ADDENDUM NUMBER 1:
Route 1 South Utility Project
January 18, 2018

This Addendum forms part of the original document marked: **Route 1 South Utility Project.**

PROJECT: ROUTE 1 SOUTH UTILITY PROJECT
FALMOUTH, MAINE

F 24" x 24" x 18" HANDHOLE
N.T.S.

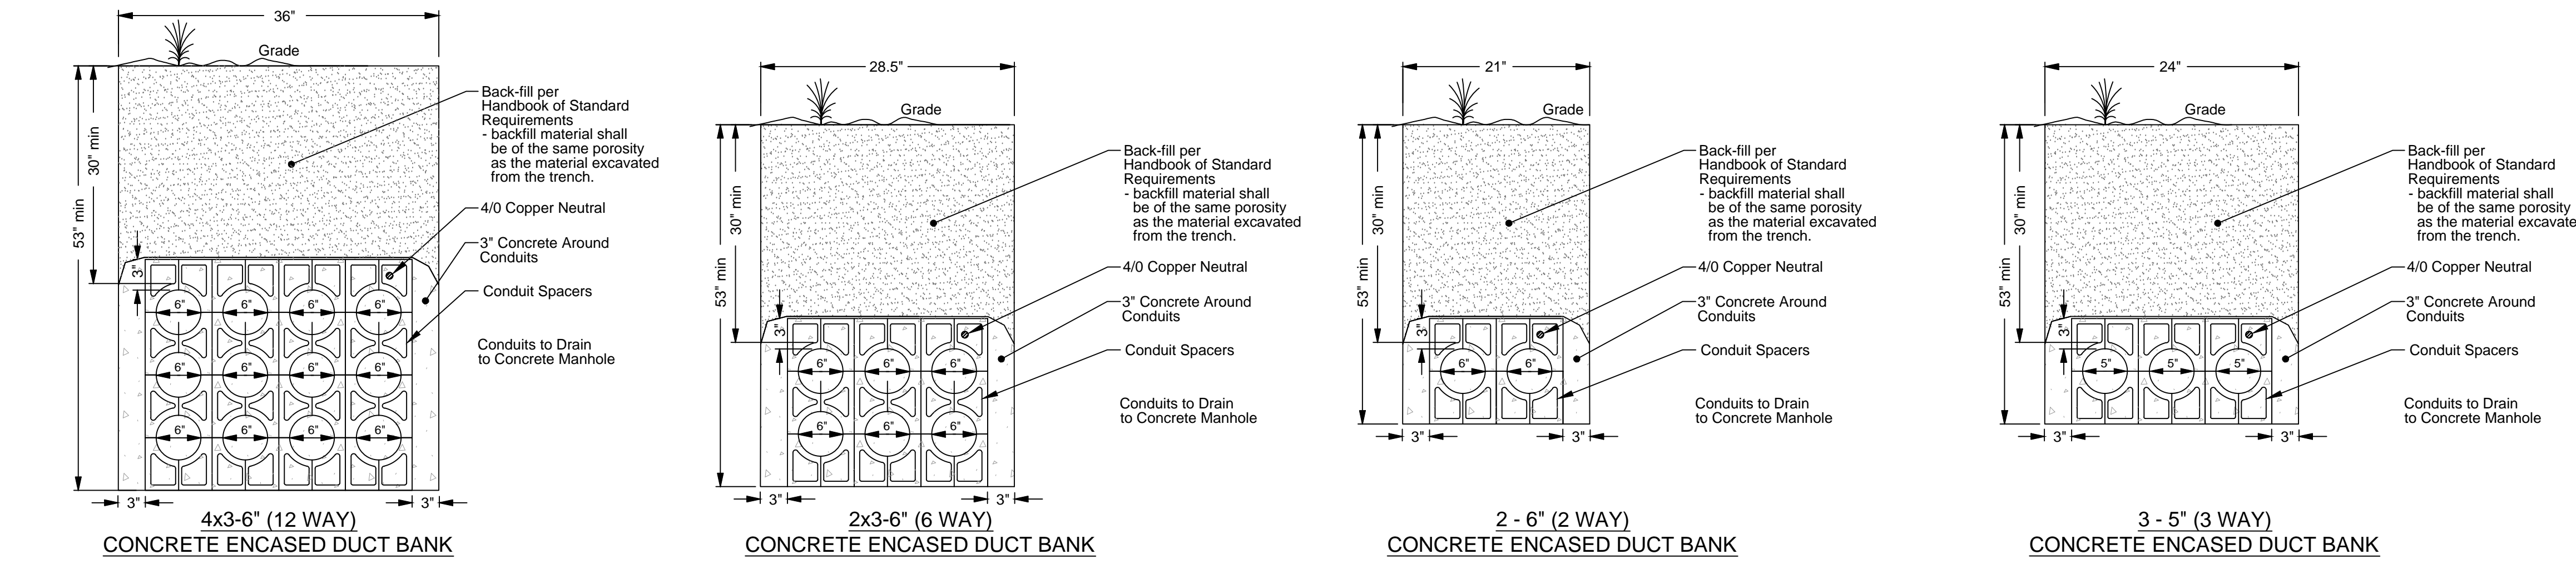
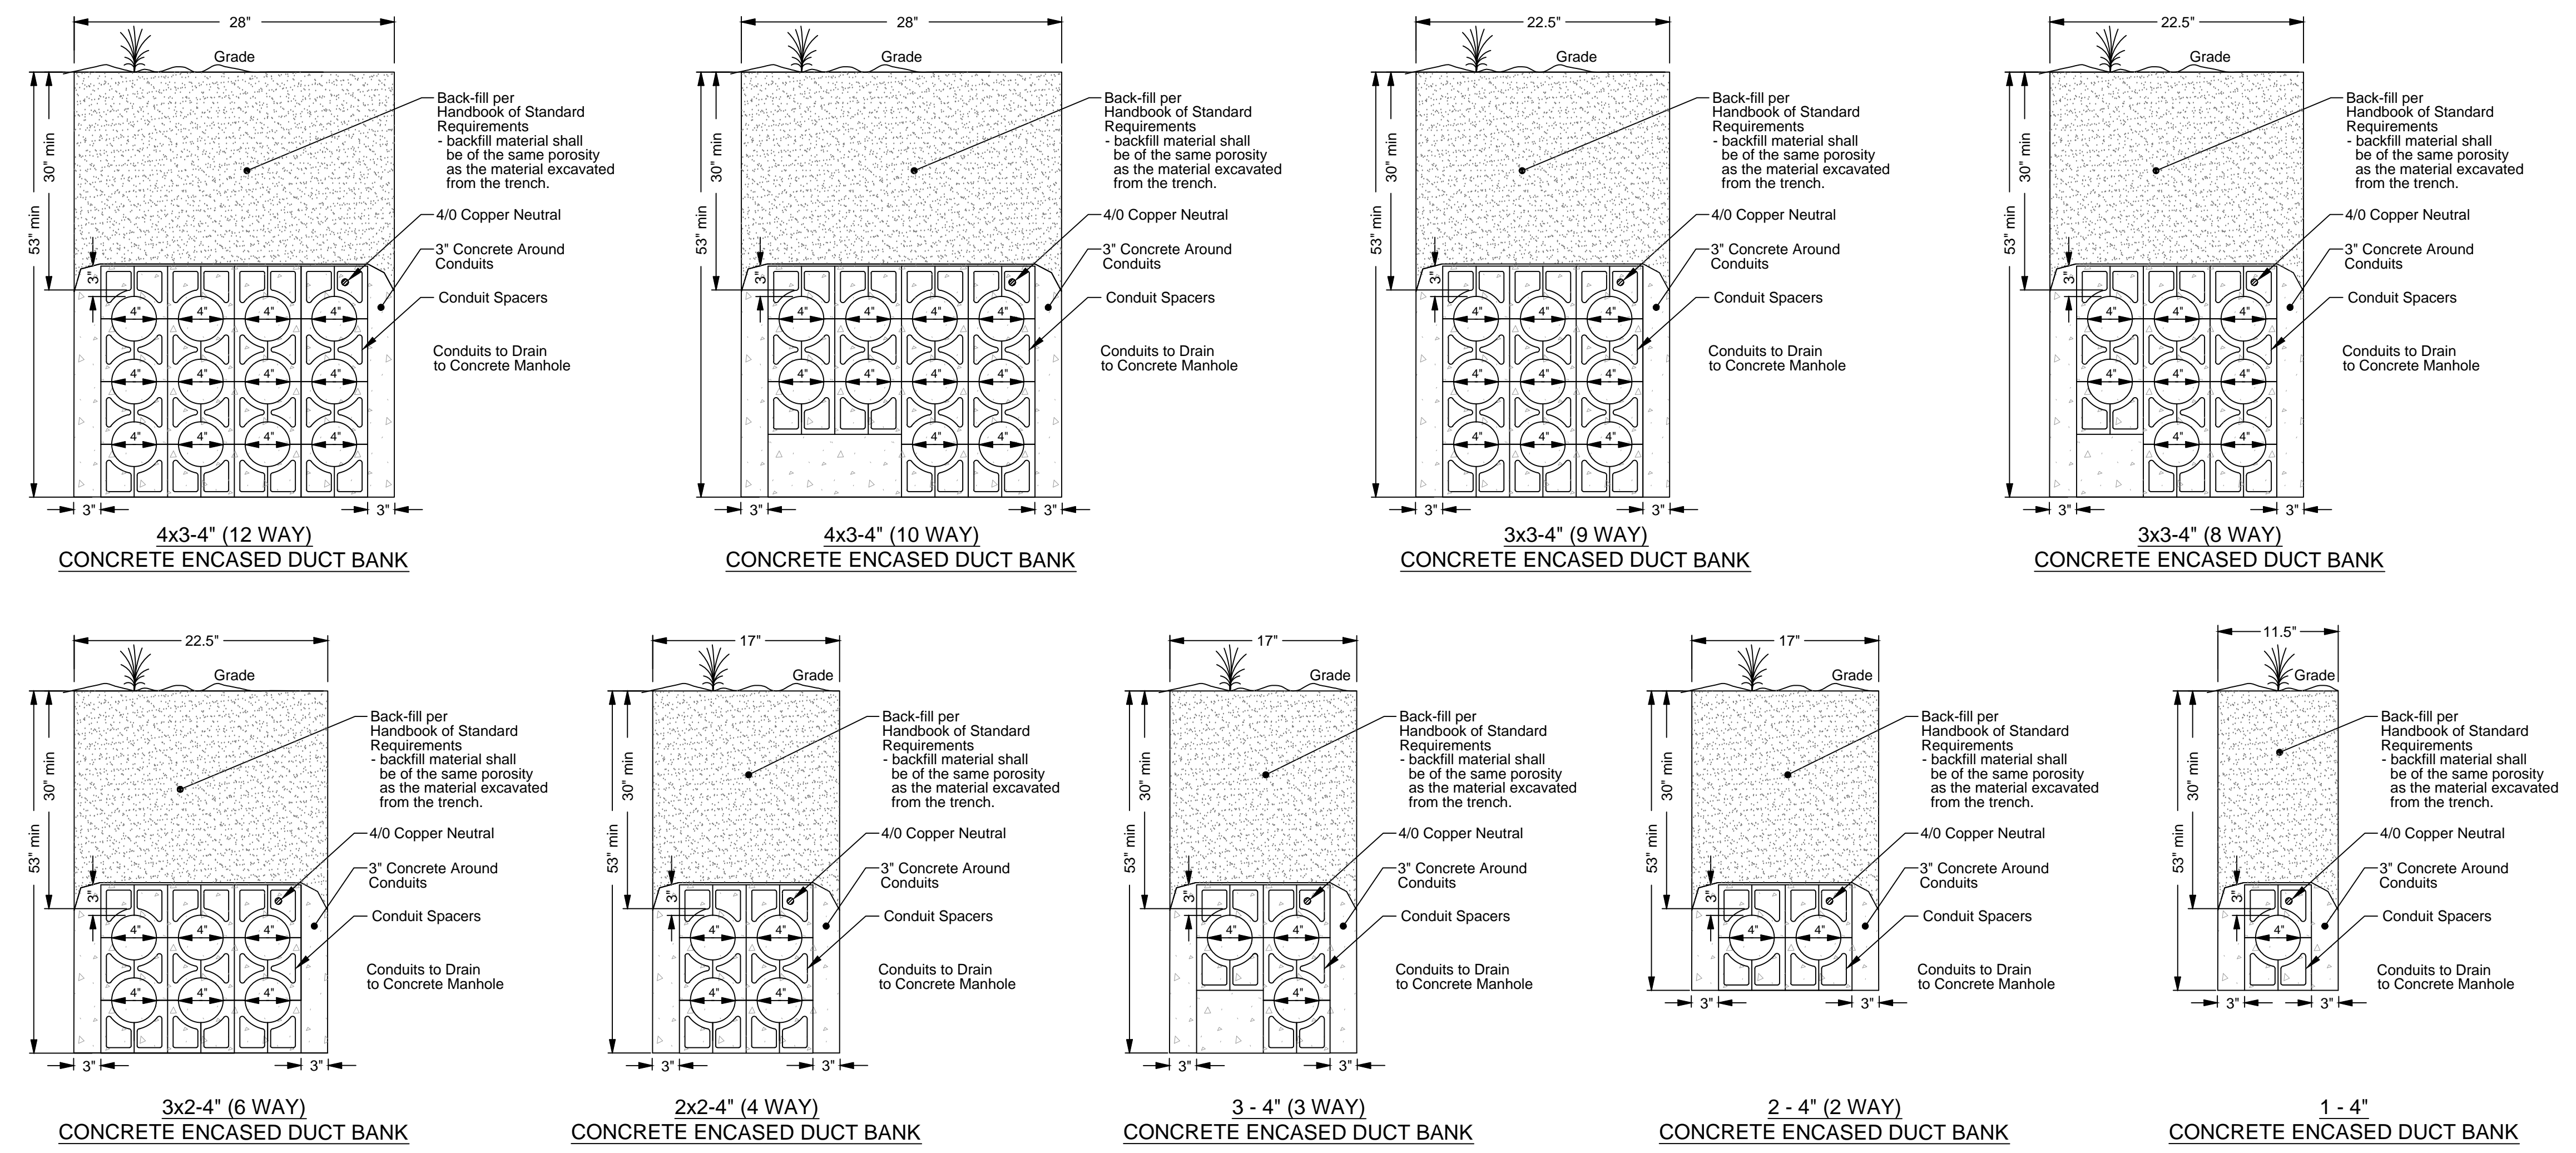
5). **ADD SHEETS 6A and 6B OF 6 (attached):**

Detail sheets 6A and 6B have been added to the set to include the following details:

- Pavement Restoration Section – Driveways and Non-Roadway Areas
- Pavement Sawcut Detail
- Single Phase Transformer Pad
- Utility Trench – Secondary Electric, Tel. & Comm.
- 4'x6' Splice box with 32" Round Cover
- Electric Duct Bank Details
- Duct Bank Details – Telephone, Cable TV, Communications, ETC.
- 24"x24"x18" Hand Hole Details
